SERVICE BULLETIN 44, Revision A

SUBJECT: GLASAIR FT NOSE LANDING GEAR MODIFICATION

APPLICATION: All Glasair I FT aircraft

MANUAL REFERENCE: FT Appendix, page D-46, FIGURE (D-34).

FIGURE (1)

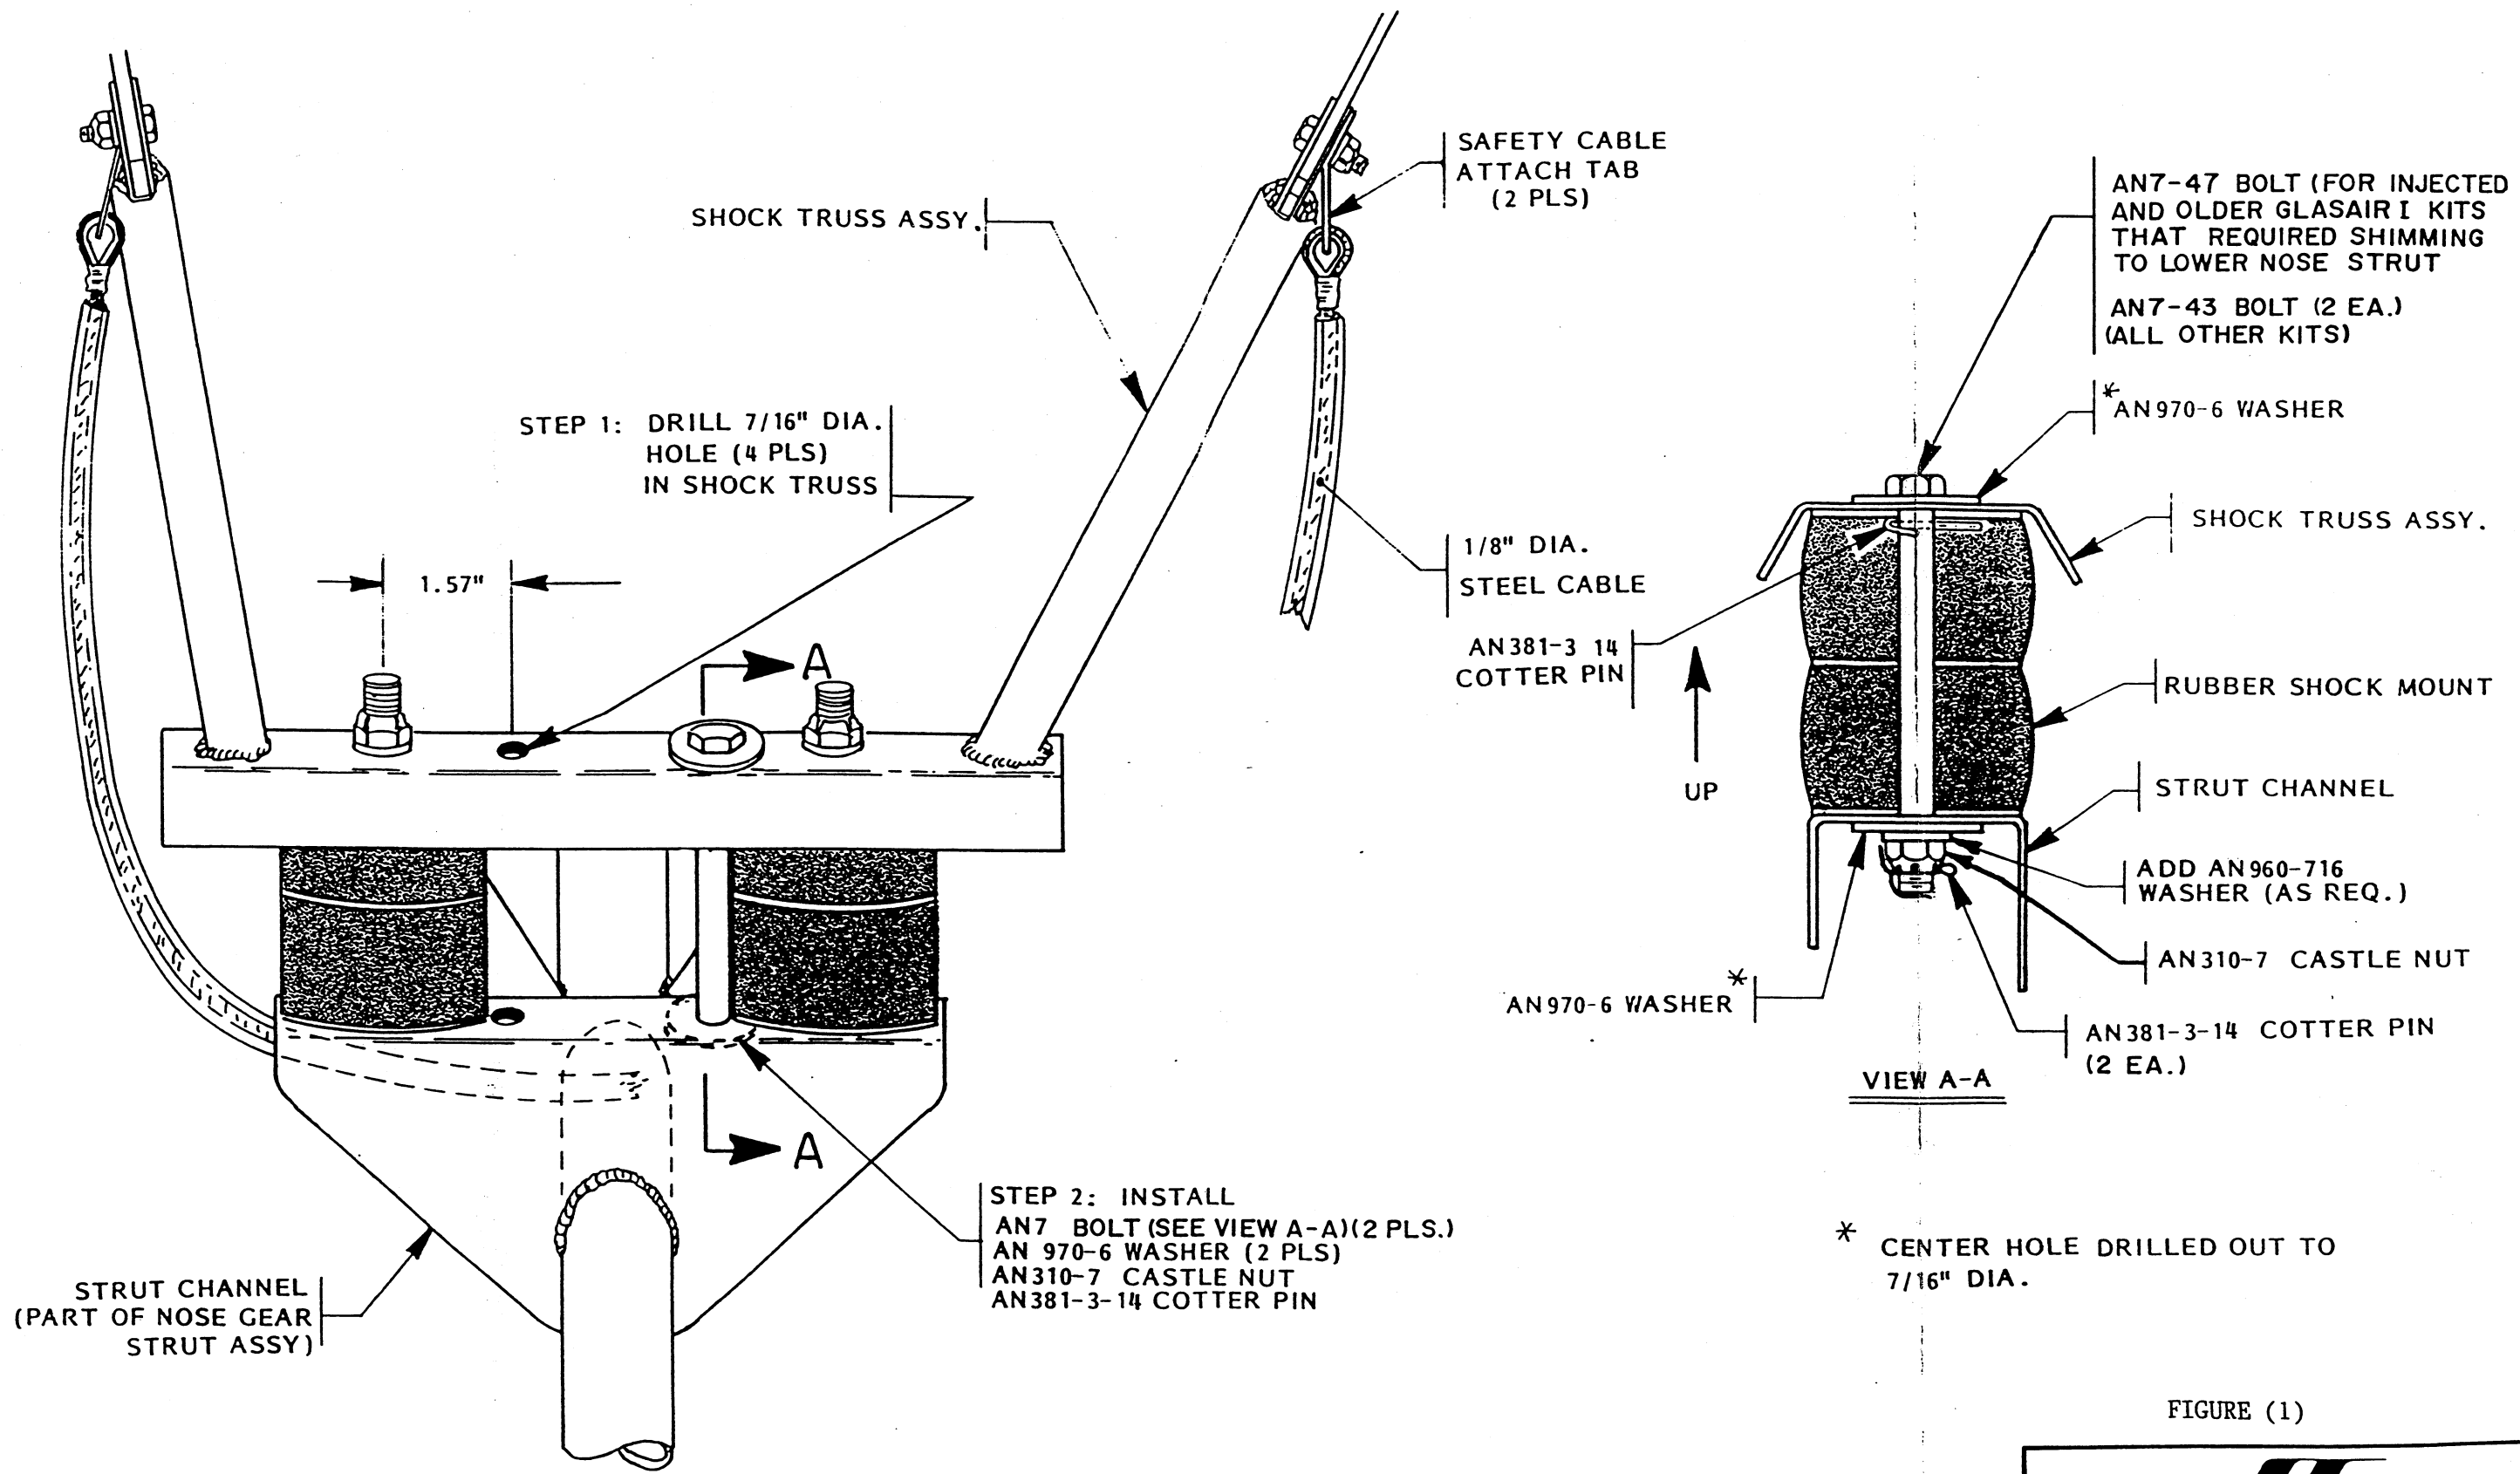
DESCRIPTION: The single length of 1/8" diameter safety cable has been found to be inadequate to withstand the drag loads imposed on it during some unusual landing conditions. Builders have experienced failure of the safety cable and subsequent shearing of the rubber shock mounts. The result has been for the nose gear assembly to fold under the airplane and to either shear off or cause the airplane to slide on its lower cowling.

5. Assemble the shock truss assembly to the strut channel assembly using the rubber shock mounts. Insert the AN7 bolts and washers into the landing gear assembly, as shown in View A-A FIGURE (1).

NOTE: If interference problems exist between the bolt heads and cables or wires immediately around them, drill a 3/32" Dia. hole in each bolt shank immediately below the shock truss assembly, as shown in View A-A FIGURE (1). Install a AN381-3-14 cotter pin to restrict the upward movement of the bolt, in the shock truss assembly.

SOLUTION: To prevent the drag landing gear loads from being absorbed by the rubber shock mounts and the safety cable, we require the installation of (2) AN7 bolts between the shock truss assembly and the nose landing gear strut channel. All drag loads will be transferred to these bolts and will not be transferred to the rubber shock mounts which are designed only to handle compression loads. Older Glasair I's and Glasair I's with injected engine mounts require AN7-47 bolts. All other Glasair FT's which did not need shims in the shock absorber assembly to lower the nose gear strut require AN7-43 bolts.

STEP 1: DRILL 7/16" DIA. HOLE (4 PLS) IN SHOCK TRUSS

STEP 2: INSTALL AN7 BOLT (SEE VIEW A-A)(2 PLS.) AN 970-6 WASHER (2 PLS) AN310-7 CASTLE NUT AN381-3-14 COTTER PIN
